Access Compliance Report

Public Rights-of-Way

(Curb Ramps)

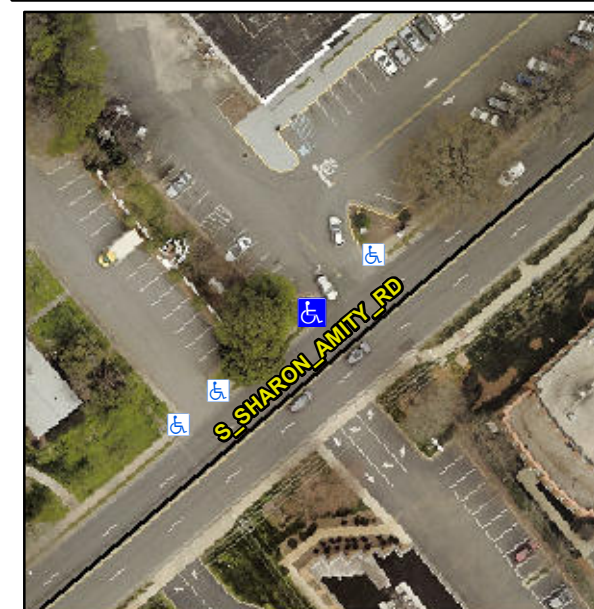
Not Found, R304.5.1, R304.2.2

Compliance	Description	Data	Compliance	Description	Data
N/A	Ramp Length (in)	64.0	No	Ramp Slope (%)	16.9
No	Ramp Width (in)	41.0	Yes	Ramp XSlope (%)	1.4
N/A	Flare Type LT	N/A	N/A	Flare Type RT	N/A
N/A	Flare Slope LT (%)	N/A	N/A	Flare Slope RT (%)	N/A
N/A	Flare Traversable LT?	N/A	N/A	Flare Traversable RT?	N/A
N/A	Landing Length (in)	N/A	N/A	DWS Provided?	N/A
N/A	Landing Width (in)	N/A	N/A	DWS Contrast?	N/A
N/A	Landing Slope (%)	N/A	N/A	DWS Length (in)	N/A
N/A	Landing X Slope (%)	N/A	N/A	DWS Full Width?	N/A
N/A	Landing Curb? (Y/N)	N/A	N/A	DWS Offset (in)	N/A
N/A	Shared Landing?	N/A			
N/A	Gutter Ponding?	N/A	N/A	Gutter Slope (%)	N/A
N/A	Gutter Lip Ht (in)	N/A	N/A	Gutter X Slope (%)	N/A
N/A	Painted X Walk1?	No	N/A	Painted X Walk2?	N/A
	X Walk 1 Direction	To E		X Walk 2 Direction	N/A
N/A	X Walk 1 Width (in)	N/A	N/A	X Walk 2 Width (in)	N/A
	X Walk 1 Slope (%)	1.2		X Walk 2 Slope (%)	N/A
	X Walk 1 X Slope (%)	1.9		X Walk 2 X Slope (%)	N/A

Remove & Replace Entire Ramp.
